**From:** Alexander, Donald H  
**Sent:** Thursday, August 04, 2011 10:33 AM  
**To:** Lagdon, Richard H; Branch, Stanley; Knutson, Dale E; Samuelson, Scott L; 'Charboneau, Stacy'; Poneman, Daniel B; 'david.huizenga@nnsa.doe.gov'  
**Cc:** Brunson, Gary E; Callahan, Victor L; Harrington, Paul G; Wicks, James H; McNulty, Richard R  
**Subject:** Tests Verify Faulty NNV Decision will increase EAC \$\$\$\$  
**Attachments:** Info Tests July August 2011.pptx

Unfortunately the Decision to Weld the Non-Newtonian Vessels was made a day too soon. Based on the testing yesterday evening and the recent testing results it is clear that the Decision to Weld will require rework and place unacceptable liability upon the government. It is too bad that the DPO Process was not fairly brought to closure prior to this decision. The following provides a technical basis for my statement:

Fig. 4 Typical erosion marks in AISI 304 and AISI 420 steels surfaces for (a and c) grazing and (b and d) normal impact

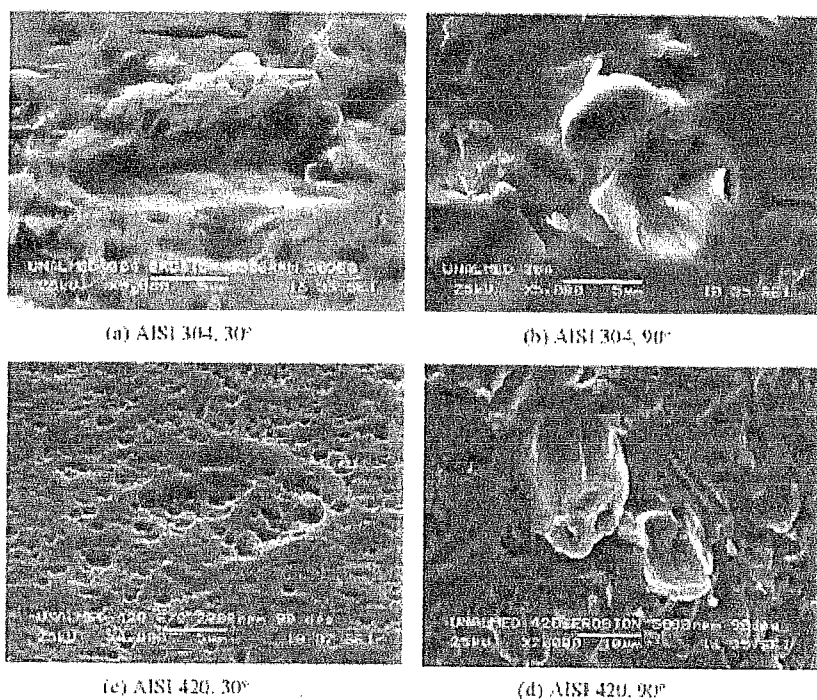
Studies of stainless steel erosion/corrosion using quartz sand<sup>[1]</sup> ranging in size from 200 to 300 microns typical of Non-Newtonian simulants shows that “*the most severe condition was obtained for grazing incidence and high impact velocity.*” Tests were run at 4.5 and 8.5 meters/second. According to the study, “*oblique impacts cause formation of grooves and prows, while normal incidence of the particles leads to craters and indentation like marks.*” The erosion effects from Lopez et al, 2005 can be seen in the photomicrographs below.

WTP will experience much more severe abrasion since the jets are operated at 12 meters/second (as compared to 4.5 and 8.5 meters/second in the tests by Lopez et al. 2005). Erosion will place a limit on jet velocity at least for vessels (both Newtonian and Non-Newtonian) that manage high solids. The Newtonian and Non-Newtonian vessels of concern will have a full scale velocity of about 12 meters/second. The materials carried by the jet will include large amounts of abrasive material as compared to the simulant used in M2 testing. These fragments will accelerate erosion. Some minerals will become rounded. Others will cleave and retain sharp edges.
